**RE:**     **2020 Periodic Safety Inspection**  
          **Tailings Main Dam (NID ID#AK00201)**  
          **Red Dog Mine**

**2020 Periodic Safety Inspection  
Tailings Main Dam (NID ID#AK00201)  
Red Dog Mine  
Northwest Arctic Borough, Alaska**

NewFields Project No. 475.0433.000  
November 2020, Revised March 2021

**Figure 4 – P-18-171-C Water Elevation**

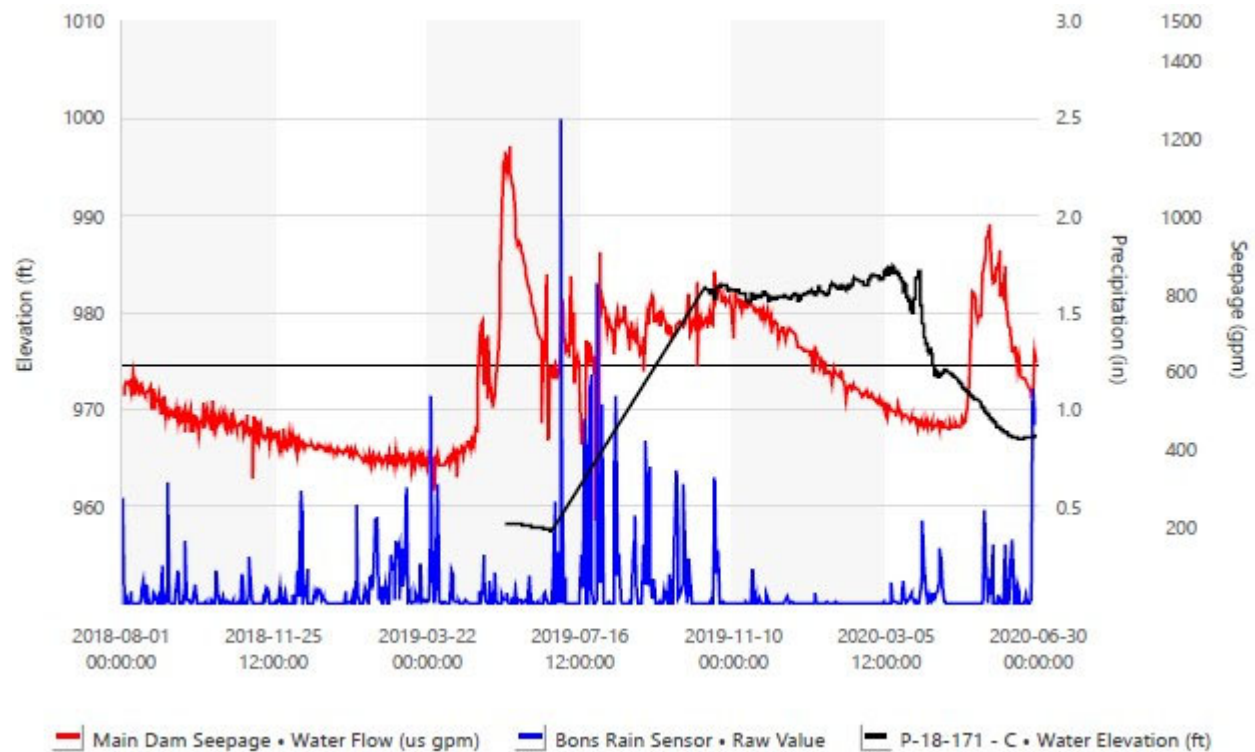
Piezometer P-18-171-C indicates a decrease in pressure head between approximately late March and May 2020 (Figure 4). While P-18-172 indicates a sharp increase in pressure head in February 2020 (Figure 5) followed by a steady increase in pressure head which precedes the increase in the main dam seepage flow rate. Data for both piezometers, in addition to the other piezometers installed along the southern portion of the Wing Wall, is presented in Figure 6. The source and cause of the change in pressure head and subsequent leveling at these two piezometers are not explained by changes in precipitation, barometric conditions, or seasonal changes, based on the information reviewed. The most recent instrumentation assessment (TAK 2020b) found no abnormalities in the Wing Wall South embankment or piezometer data although the February 2020 (TAK 2020a) assessment did note the changes in P-18-172 as summarized in Table 4. Further evaluation of weekly reporting (TAK 2020c) and images provided by TAK and gathered

- Taken from TAK Periodic Instrumentation Assessment June 2020
- Sharp decrease noted between late March 2020 and May 2020

- Continue monitoring piezometers P-18-171-C and P-18-172 and consider further investigation of the data should they continue to trend differently than expected and other piezometers on Wing Wall.
- Evaluate the selected PMP storm event and consider selection of the 72-hour PMP storm as the design storm.

**Figure 5 – P-18-172 Water Elevation**

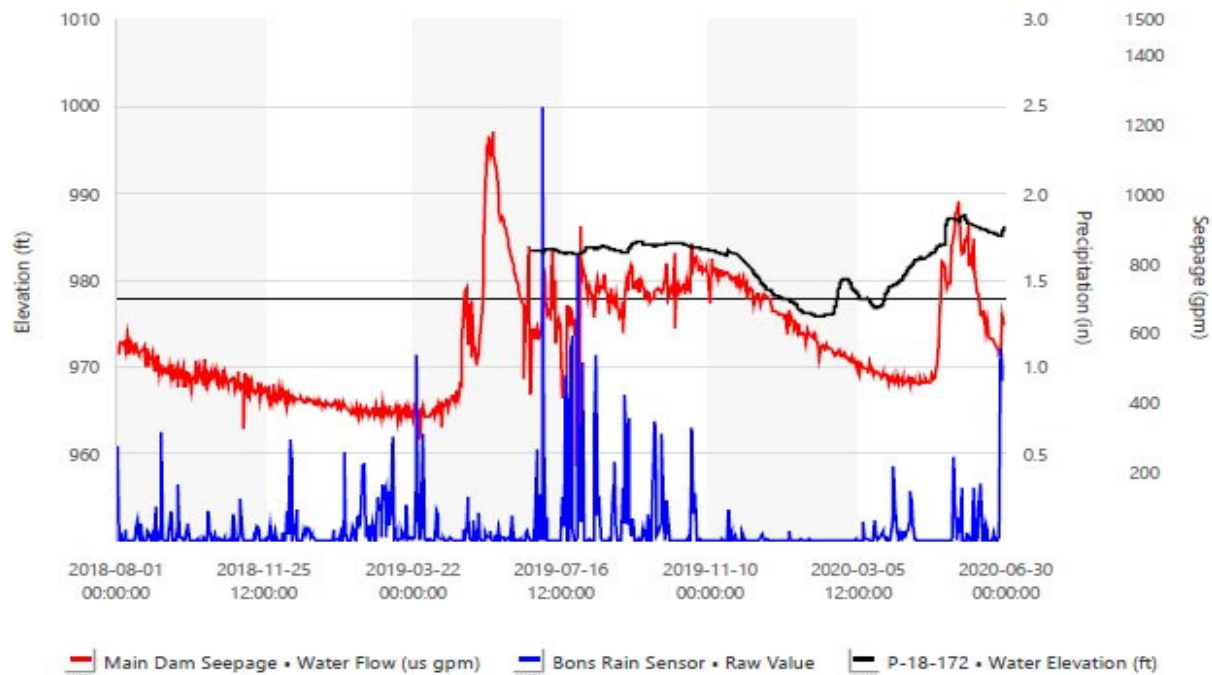
- Taken from TAK Periodic Instrumentation Assessment June 2020
- Sharp increase noted in February 2020 followed by steady rise prior to increase in Main Dam Seepage

**Figure 6 – Wing Wall South Piezometer Data (June 2020)**

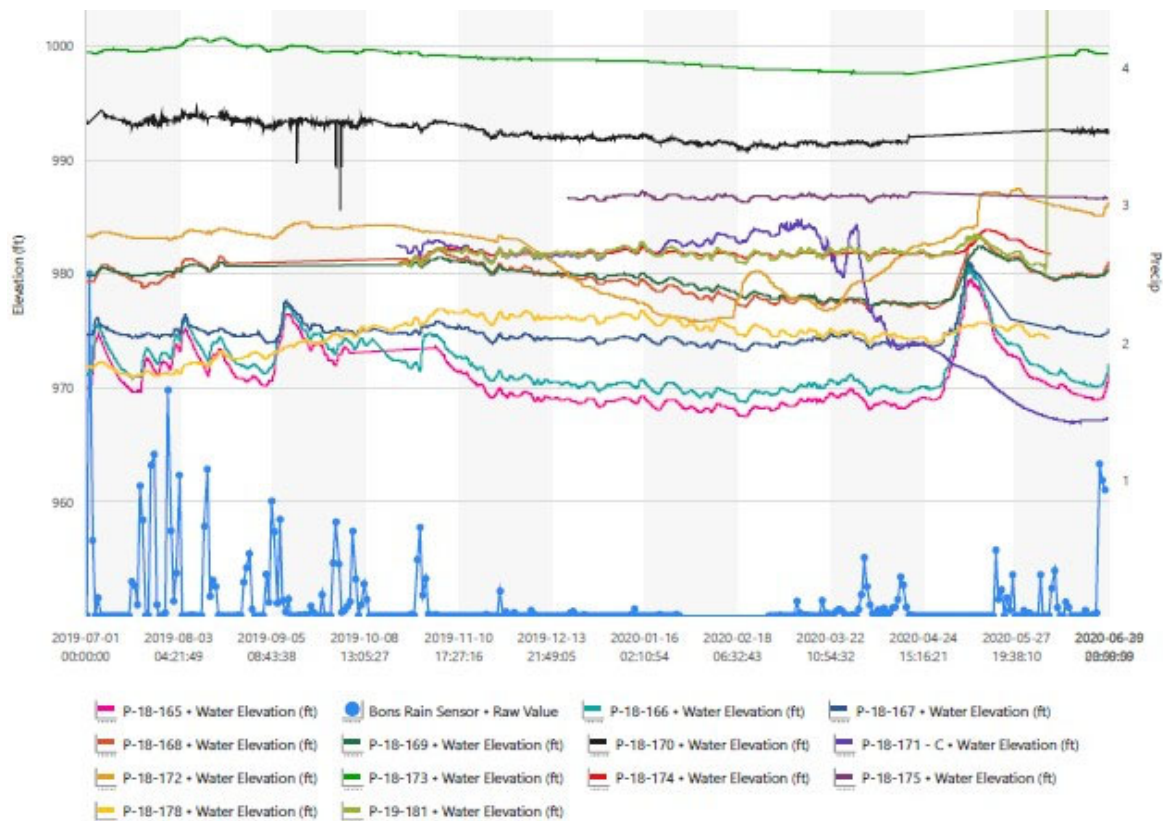
- Taken from TAK Periodic Instrumentation Assessment June 2020
- P-18-171-C data shows decrease in water level beginning in late March 2020
- P-18-172 data shows two sharp increases in water level, with subsequent leveling after each

**Photograph 02:** Seep #1 at west abutment, below Stage XI Buttress elevation (looking southwest)

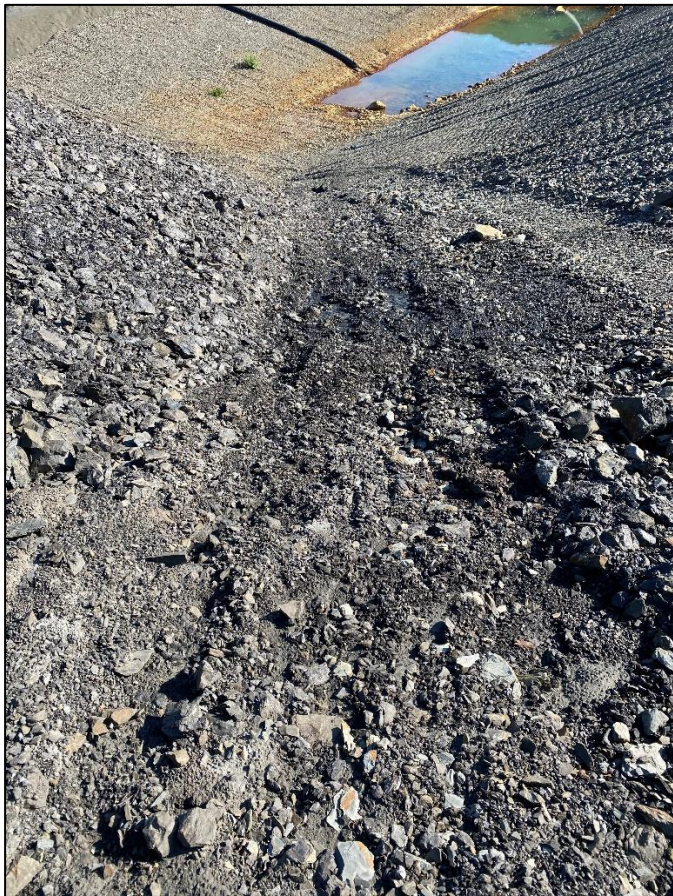
There were two areas of seepage noted along the west abutment (Photos 02, 03 and 04). These were located on the natural hillside and not on the embankment. Seep #1 was located below the Stage XI Buttress elevation while Seep #2 was located near the Stage X TMD crest elevation. No discoloration or turbidity was noted in the flows and the flow rates were estimated at less than one gallon per minute. Based on discussions with TAK personnel these seeps have been noted and are likely the result of the ground thawing in the area. These seeps do not appear to pose a stability risk to the embankment although continued monitoring of these seeps is recommended. No other signs of seepage were observed along the embankment.

- Continue to monitor and document the seeps, and any others that are identified, along the west abutment.
- Update the GoldSim water balance model to:
  - Incorporate Aqqaluk Pit and the pumping between the pit and the TSF;
